COUNCIL ASSESSMENT PANEL MEETING

AGENDA – 9.2

Applicant: Lloyd Building Solutions Pty Ltd	Landowner: B S Lloyd & J Bala
Agent: N/A	Originating Officer: Ashleigh Gade
Development Application:	20/1049/473
Application Description: Single storey split level detached dwelling, deck (maximum height 2.6m), retaining walls (maximum height 1m), domestic outbuilding - garage & associated earthworks	
Subject Land: Lot:391 Sec: P81 DP:123071 CT:6234/308	General Location: 34 Fern Hill Road Bridgewater Attachment – Locality Plan
Development Plan Consolidated : 8 August 2019 Map AdHi/31 & 75	Zone/Policy Area: Country Living Zone - Country Living (Bridgewater) Policy Area
Form of Development: Merit	Site Area: 964m ²
Public Notice Category: Category 2 Merit	Representations Received: 2 Representations to be Heard: 2

JOB # 20-453
SHEET # C100 REV. 1

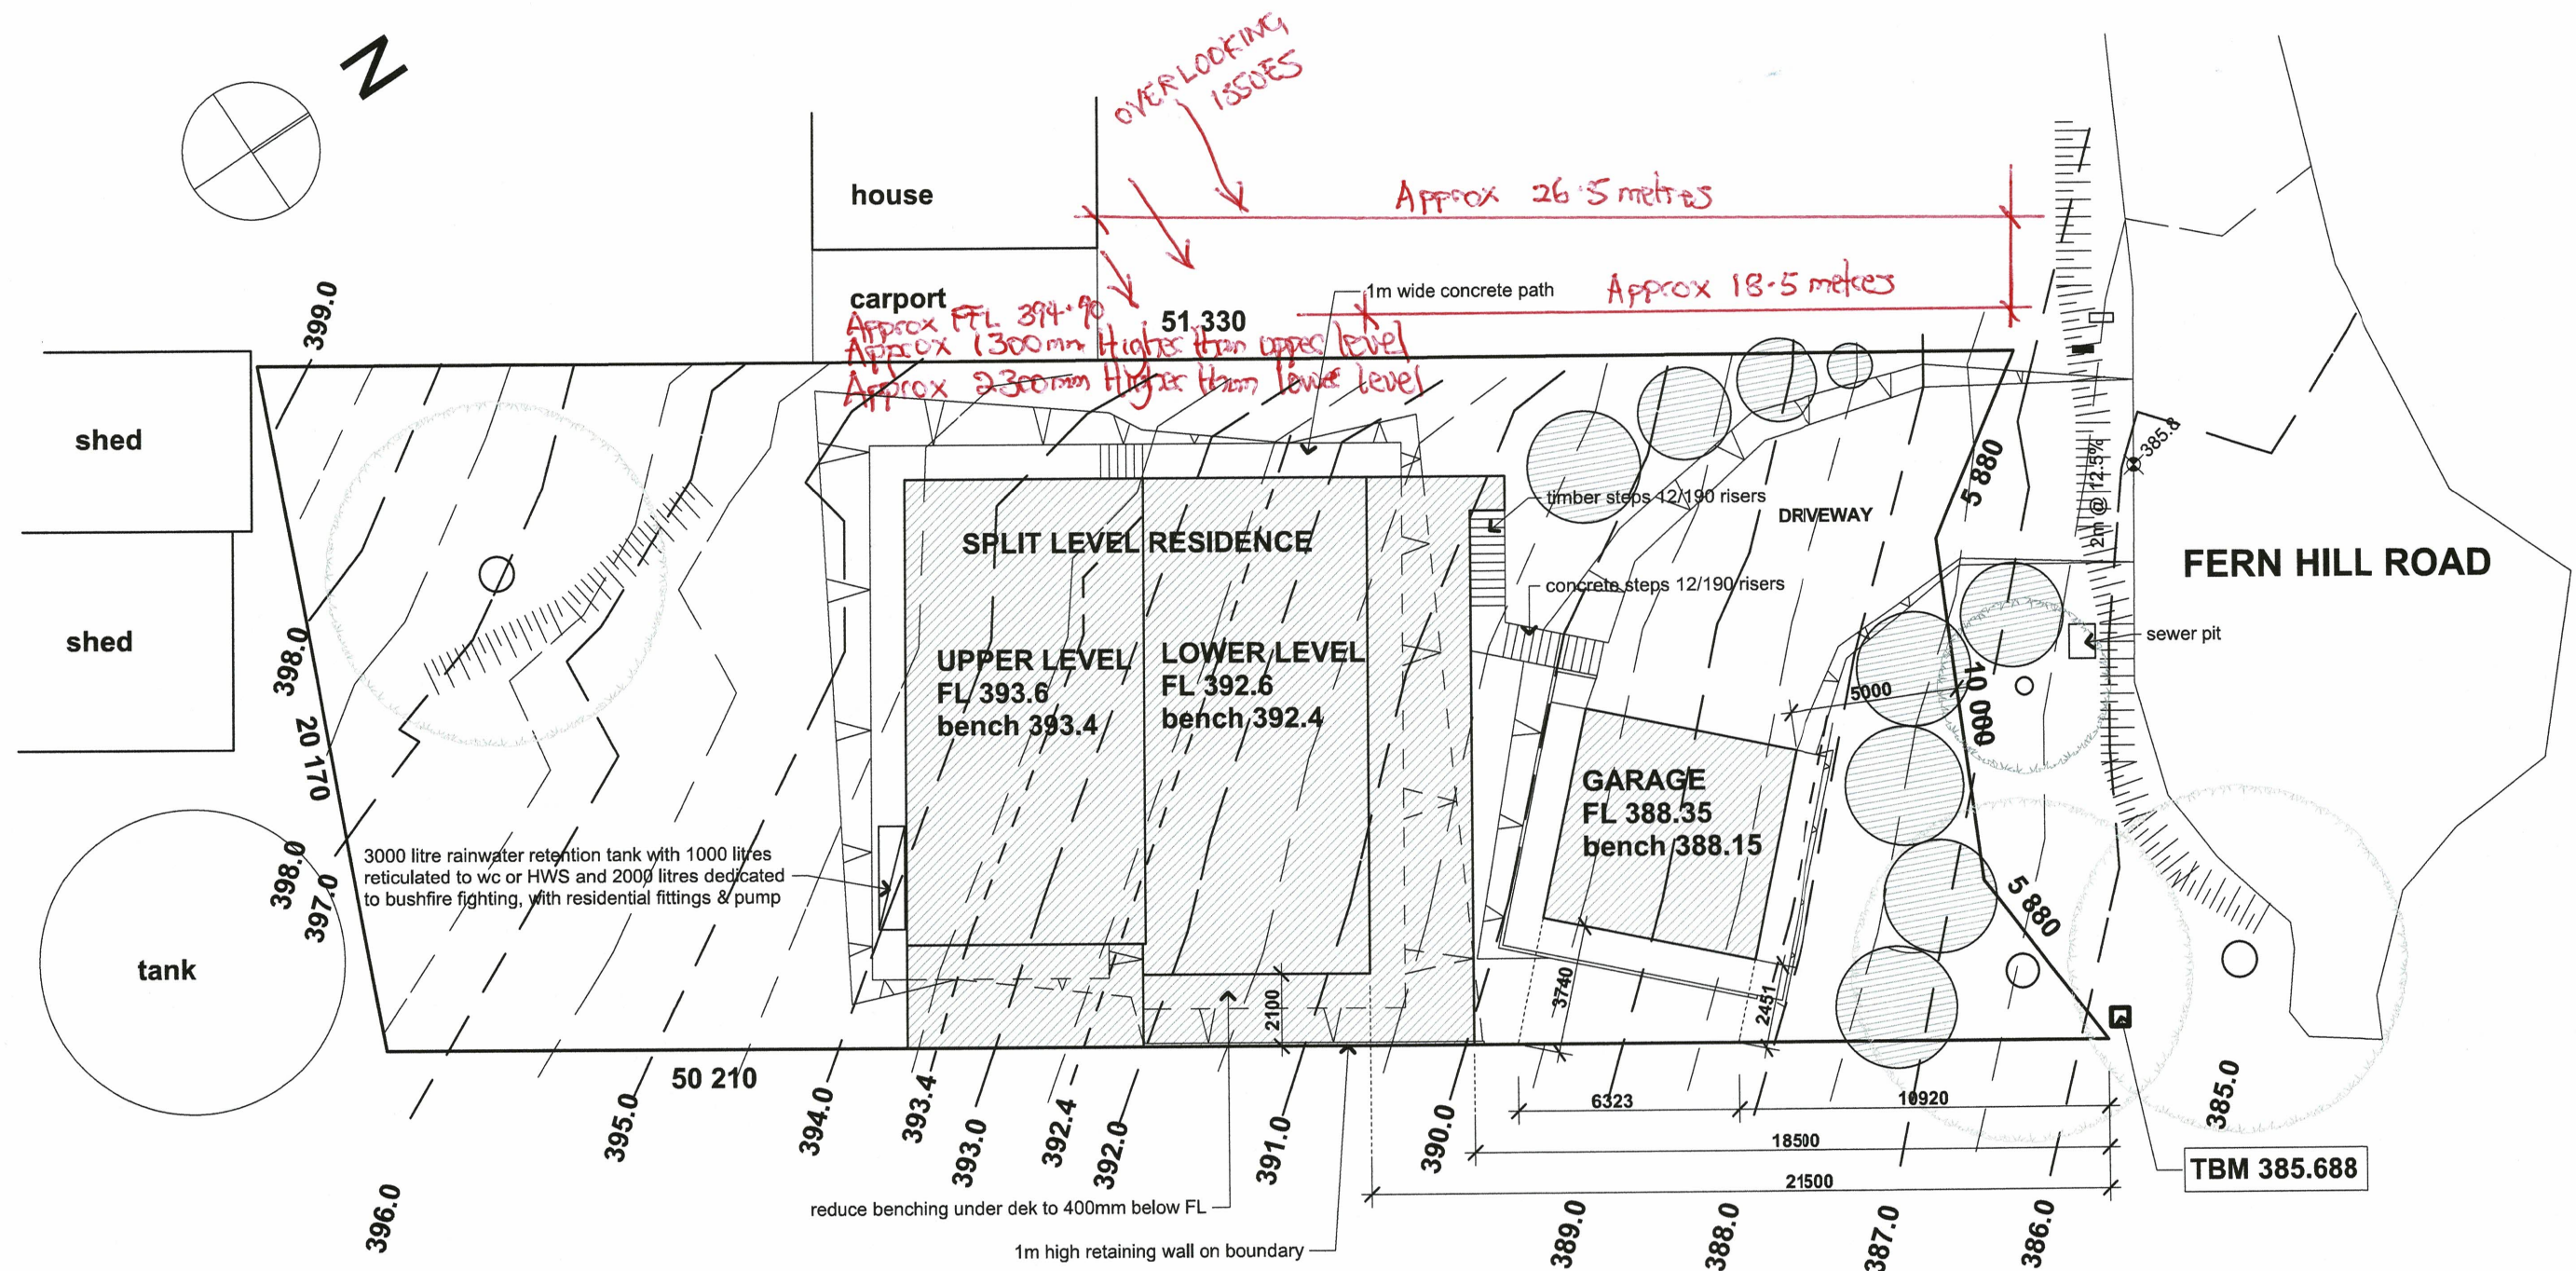
Revised stormwater plans for 20/1049. Let me know if this addresses your requests.

Find the revised stormwater site management plans and details attached as requested. They now show a 5000 litre Colourbond detention tank near the Garage to slow the flow of stormwater to the street back to pre-developed rates with supporting calculations included.

The retaining wall heights are now noted with a "Snip" detail of the rear Garage retaining wall noting a maximum retaining wall height of 1.0m in this and all other placements on the block, which brings all back to a landscape detail not requiring the retaining walls be designed by the Engineer.
